***Shared Use Routes for Pedestrians and Cyclists* – Peer Review note by CTC**

We welcome the opportunity to respond to the document, which is a welcome piece of guidance to help improve provision of routes for cyclists.

Figure 4.2
Diagram of cycle facility solutions based on motor traffic volume and speed

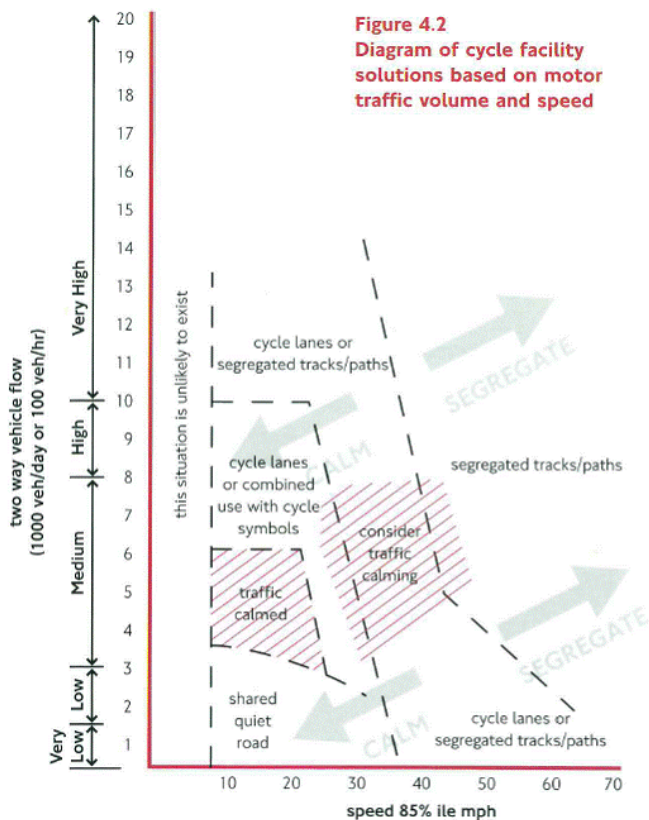
We also urge the inclusion of the speed/flow diagram as employed in Transport for London’s *London Cycle Design Standards* (see below) either here or in Chapter 4. The table given in LTN 2/08 (table 1.3) is reasonable, but the TfL version expresses more clearly the hierarchy’s vision of reducing speeds or traffic volumes where appropriate.³
